**AFTS 629/11/14/RPRT-001**

**CRITICAL REVIEW OF THE KALKARA SYSTEM  
SAFETY AND HAZARD ANALYSIS**

ISSUE:	1				
DATE:	25-Mar-99

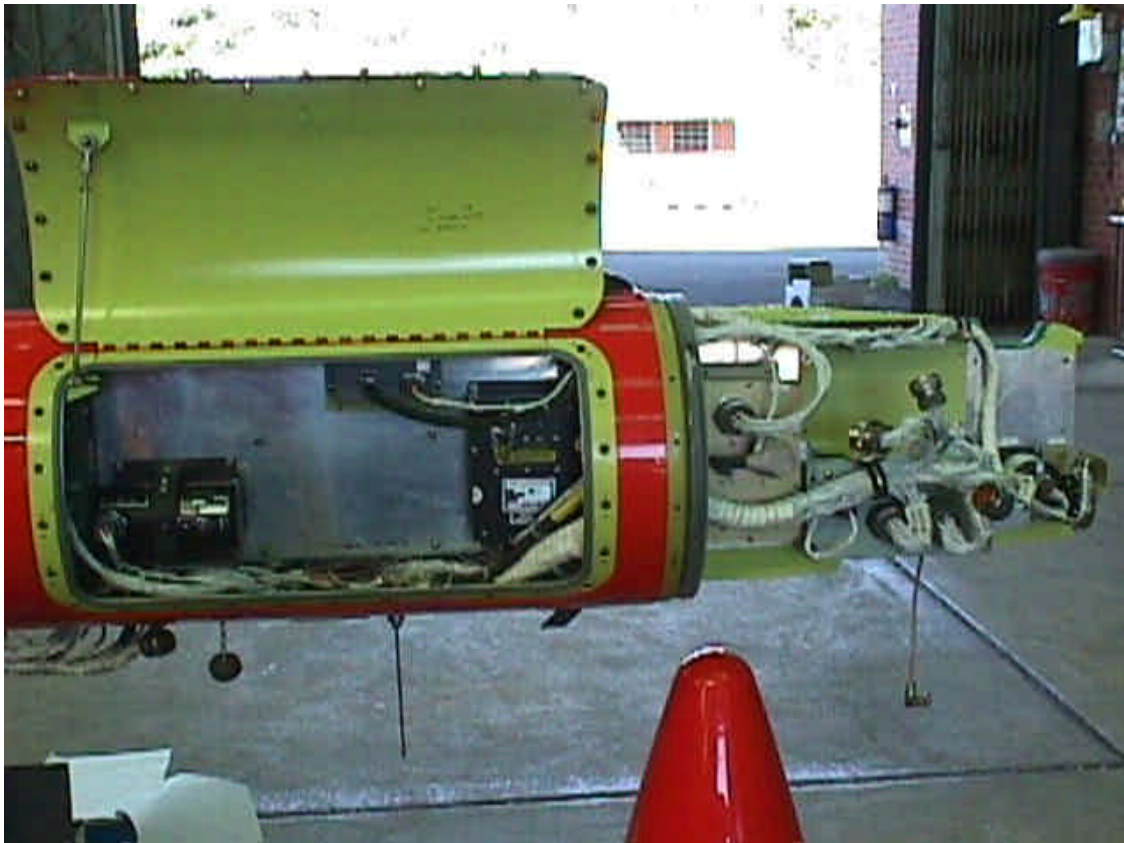
4.6.1.1 Due to the normal sea recovery operational procedure of Kalkara, as a system environmental specification requirement, it is appropriate that the Kalkara design specifications require:

- a. for many system components, an environmental specification and qualification for seawater immersion; the components include:
  - (1) EED,

- (2) Magnetometer,
  - (3) Control surface servos,
  - (4) tailcone micro-switch,
  - (5) drogue and parachute actuation system, including electro-explosive devices, and
  - (6) flight control box;
- b. for many more system components, on the presumption that the nose avionics compartment is water-proof qualified, an environmental specification and qualification for saltwater contact; the components include those located in the avionics nose compartment, notably:
- (1) yaw rate gyro,
  - (2) vertical gyro,
  - (3) batteries,
  - (4) power distribution boxes,
  - (5) MAGIC<sup>2</sup> boxes, and
  - (6) DAP/transponder.

4.6.1.2 Without such environmental specifications and qualifications, a substantive justification is required, as to why, without reconditioning, all seawater-exposed components should not be one-flight usage, only. Through the flight test programme, the components have been used, for any number of flights:

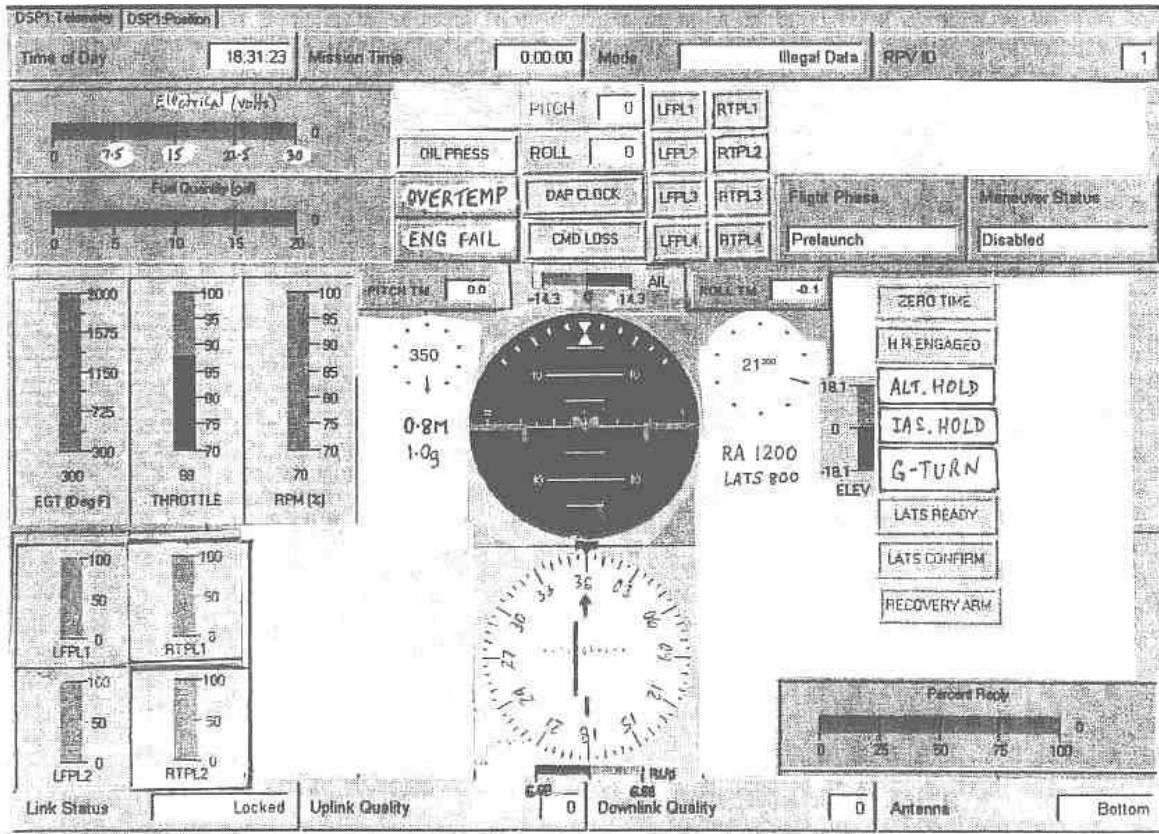
e. 23.1321(d): requires the 'standard-T' presentation of flight instruments, with which the Primary Display does not presently comply; the present display is illustrated in the following diagram.

8.10.3 In order to comply with a 23.1321(d) presentation requirement, the basic flight parameters of airspeed and altitude need to be moved to the left and right positions, adjacent to the ADI. The following example of a compliant presentation follows the contemporary standard for HUD displays, namely counter-pointer indicators for airspeed and altitude, with Mach Number and load factor alphanumerically indicated, below the airspeed indicator, and radar altitude and LATS datum radar altitude, indicated alphanumerically, below the altimeter indicator. This standard presentation declutters the flight instrument section of the Controller's Primary Display.

8.10.4 The navigation instrument presentation requirement is satisfied by the transformation of the compass indicator to an HSI. The engine and related instruments (fuel and busbar voltage indicators) are grouped together. Although the engine instruments are located in the non-standard position to the left of the airspeed/Mach indicators, being adjacent to the airspeed indicator maximises sensory perception of the power/performance relationship; engine OVERTEMP and ENGINE FAILURE annunciators have been added to the CAP, and normal autoflight system status annunciators (coloured green, as opposed to the two emergency conditions, LOC and loss of DAP clock, coloured red) grouped alongside the primary flight display section of the Display.

8.10.5 In the design of the annunciators, the contemporary 'quiet and dark' standard of aircraft design should be applied, namely that the annunciators remain unlit until activated ON by a status or condition. The Percent Reply indicator has been grouped with the UPLINK and DOWNLINK status indicators, along the bottom of the Display.

8.10.6 The aileron, elevator and rudder deflection indicators have been re-positioned, so that their sense of motion corresponds to the associated response of the aircraft.
